Ikes at Cambria
8001 28th Avenue South
PL201900209

SHEET NO:
T
TITLE SHEET

SHEET NO:
A1.2
ENLARGED SITE PLAN

SHEET NO:
A1.4
LANDSCAPE PLAN

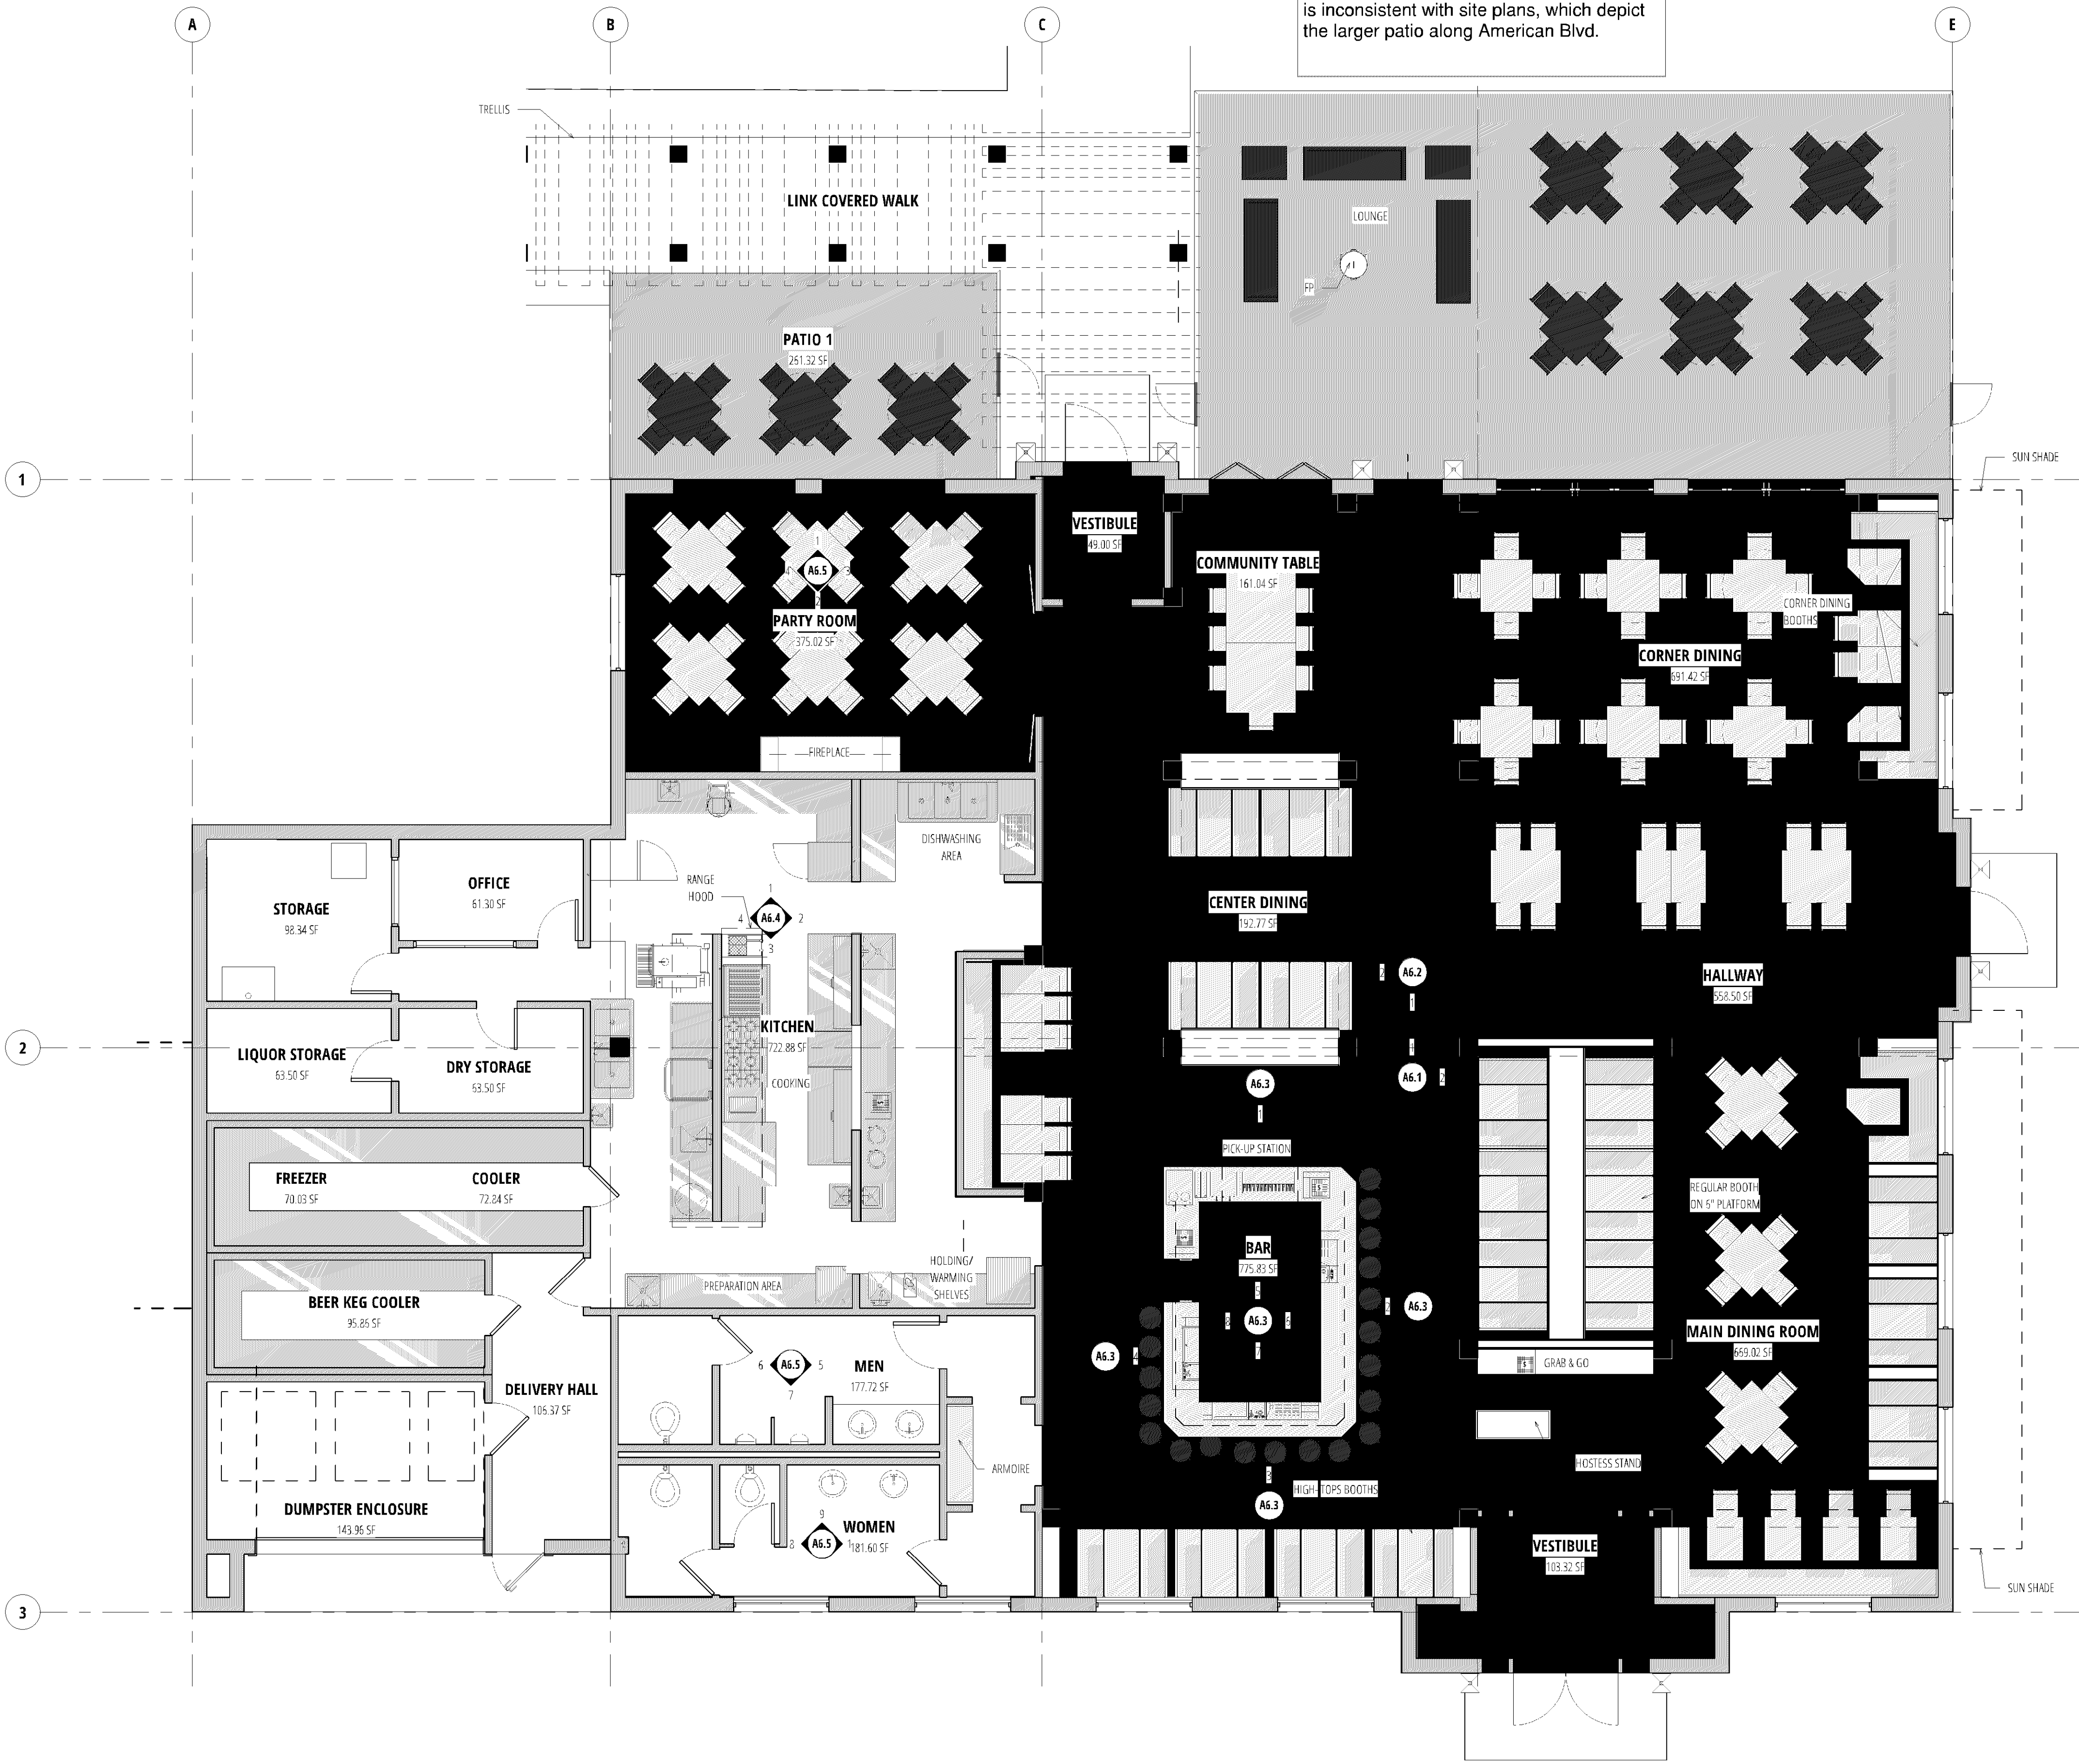
The American Blvd. frontage does not meet the minimum 30 percent building enclosure requirement.
